PRODUCT CHANGE NOTIFICATION

#PCN-DCT-J510-10

Business Unit	Product Line Code	Type of Change	Action	Date of issue
DCT	178	Aesthetic	Notify Distributors and Field	06/25/2010

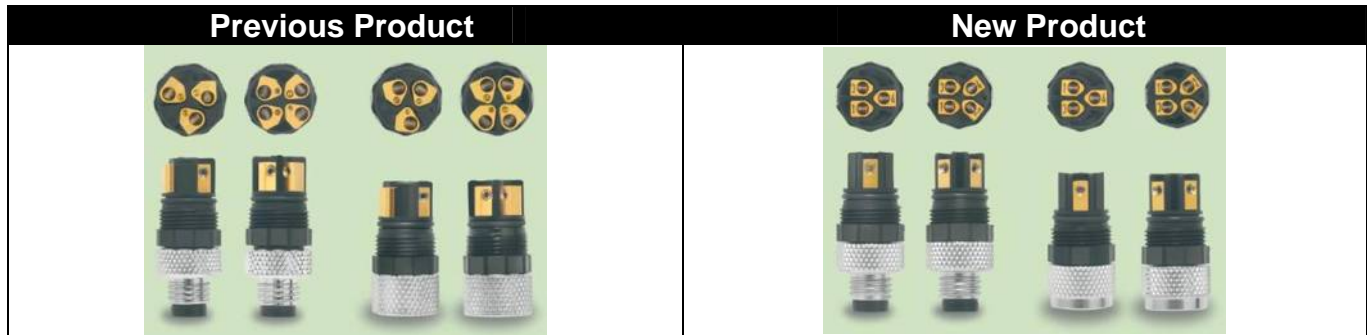
For the following SACC M8 connectors, the internal contact geometry will be changed in all 3 and 4 position plug connectors with screw connection, and numbers will be added to the contacts. The changes have no influence on the outer dimensions and electrical and mechanical characteristics will remain the same.
